**AMENDMENTS TO THE DRAWINGS:**

## **REMARKS**

# **Appendix A**

**(Marked Up Sheets For Figures 1-3)**

Fig. 1

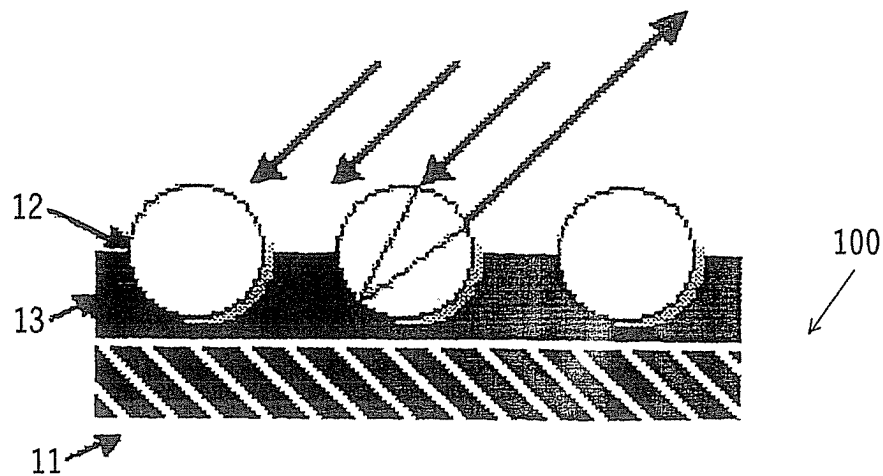
The examiner objected to Figures 1-3 because they do not include the legend "Prior Art"

ADD  
DESIGNATION

(PRIOR ART)

Fig. 2

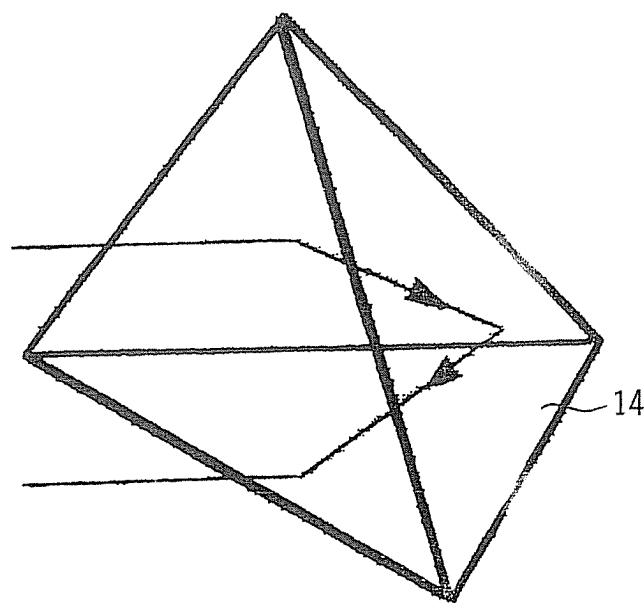
ADD  
DESIGNATION

(Prior Art)

Fig.3

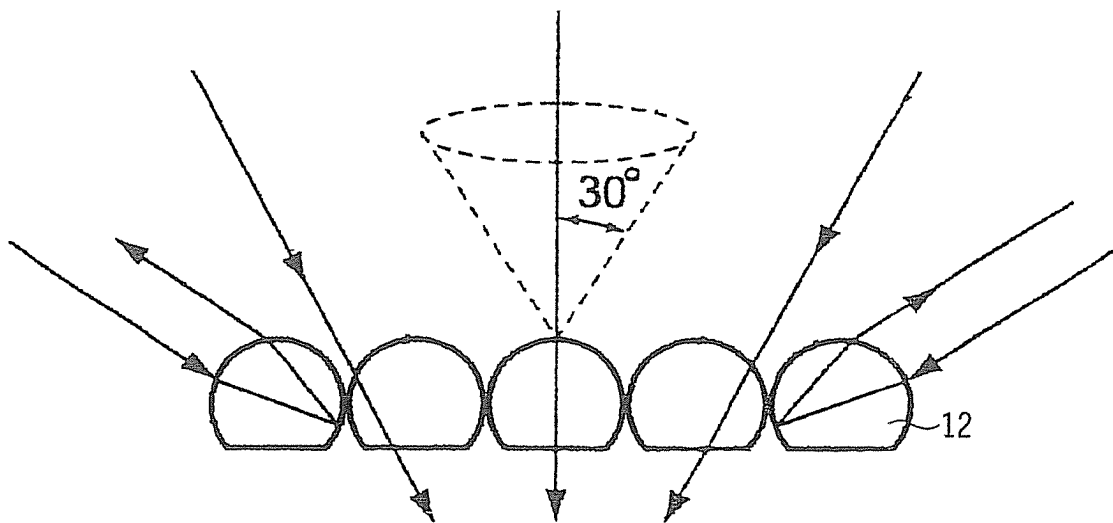
ADD  
DESIGNATION

(Prion Art)
